**From:** "Larry Harmon" <lharmon@safetylight.com>  
**To:** "John Jankovich" <JPJ2@nrc.gov>  
**Date:** 4/23/03 1:36PM  
**Subject:** RE: Request for Additional Information

**From:** John Jankovich [mailto:JPJ2@nrc.gov]  
**Sent:** Monday, April 21, 2003 12:27 PM  
**To:** lharmon@safetylight.com  
**Cc:** Nima Ashkeboussi; Ujagar Bhachu  
**Subject:** Request for Additional Information

Description of assembly of parts previously manufactured by Self Powered  
Lighting

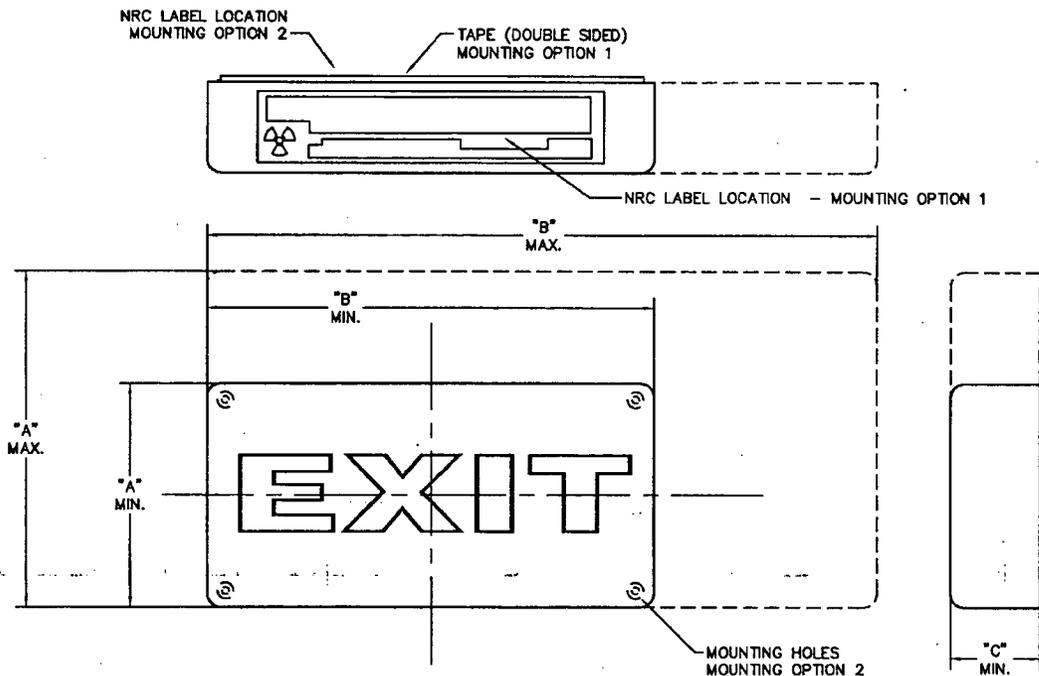
1. Provide an electronic version of a generic drawing for your exit signs. For example, the drawing of Model AC/6 can be generalized by removing the dimensions and substituting with the letters "a, b, and c," and we will add a table to reflect these dimensions for the model series AC/2 through AC/29.

Hi John. I am attaching to this email the items to satisfy 1 and 2 below. The devices are listed on Self Powered Lighting license 1406-1611 GL. These devices should be added to Safety Light Corporation registration certificate NR-0579-D-112-G. Please disregard model 618-5790. It was my error. It is an obsolete part. If you need anything else please give me a call.
